6 July 2021

SSD7009: Marulan South Limestone Continued Operations Project

Reference is made to the abovementioned Development Application (DA) currently under assessment by the Department of Planning, Industry and Environment (DPIE) and your correspondence of 21 June 2021 seeking the following additional information:

ATTACHMENT 1: DISTANCE FROM BLAST FACE TO RECEIVERS

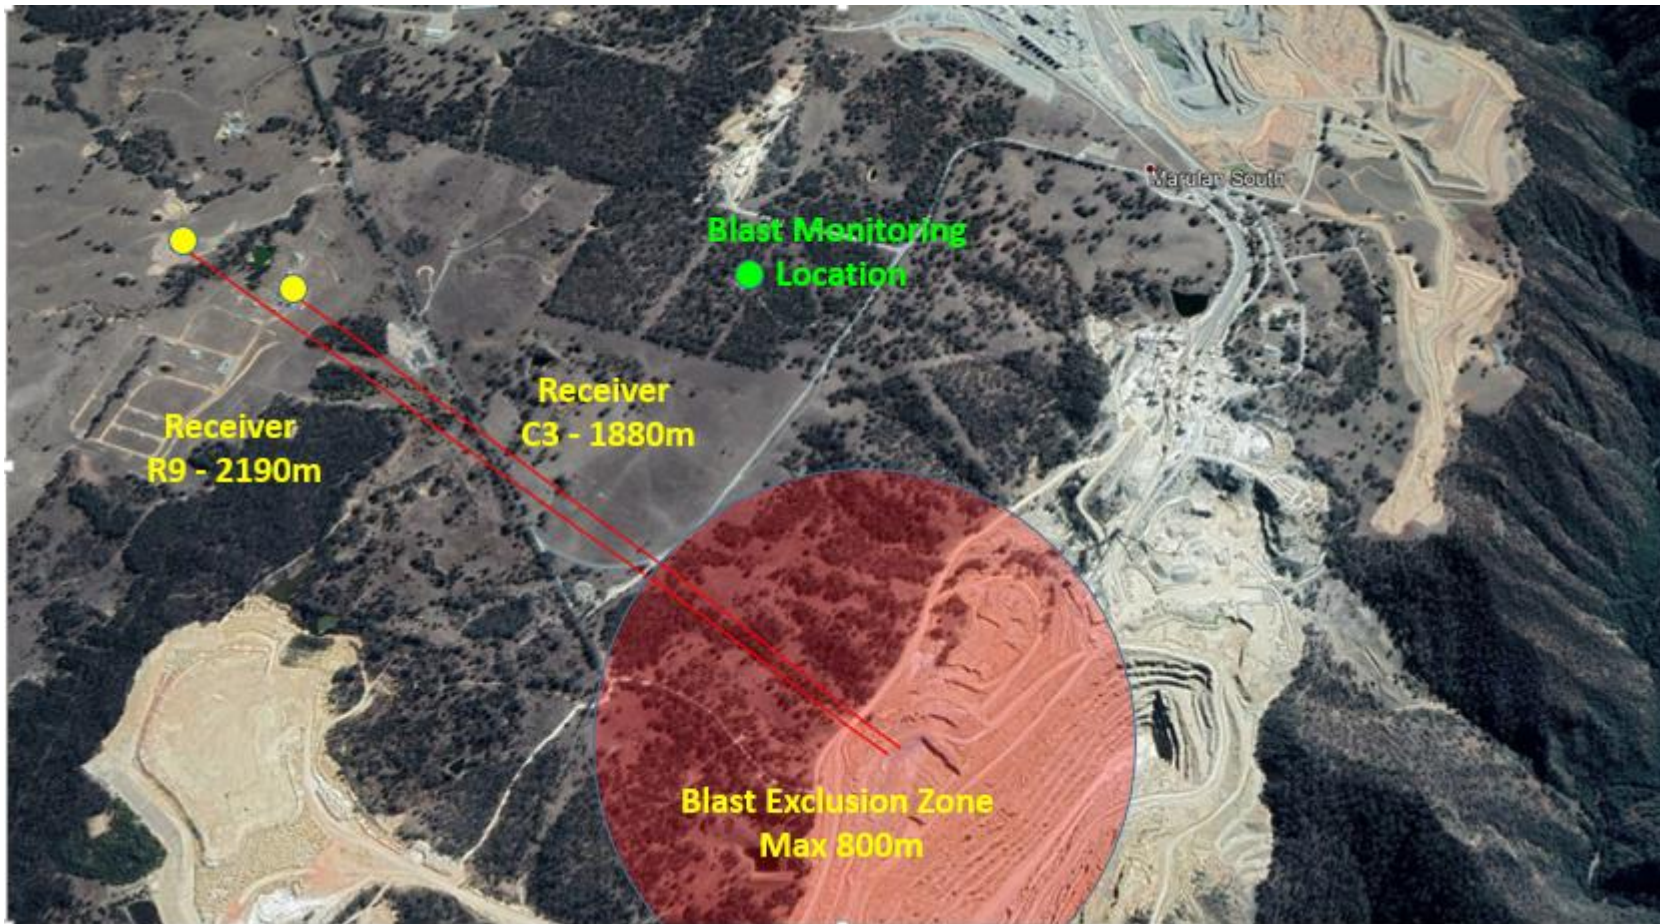
- An overview of the risk of flyrock impacts are currently managed, and would continue to be managed over the life of the Project;
- The minimum setback distance between blasting activities and the nearest privately-owned receivers (C3 and R9); and
- The location(s) at which blast impacts on commercial receivers were modelled.

Table 1 below contains a summary of the identified receivers and their distance from the existing operation and are plotted on the figure provided at **Attachment 1**. This figure also identifies the approximate location of blast monitoring at receiver location "B5" (refer to section 19.3.5, p. 363 Element Environment; 2018).

The receiver location B5, is significantly closer to the mine than the closest residential or commercial receiver and has not recorded any historical breaches of compliance with the blasting criteria. Moreover, no blast complaints have been received by the mine.

Distances have been measured from current area of operations from where blasting activities are undertaken. It is noted that all receivers are located outside the 800 metre blast exclusion zone and at a relative ground level far below that of the receivers themselves.

Receiver	Direction	Distance (metres)
Commercial Receiver – C3	North-west	1,880
Residential Receiver - R9		2,190
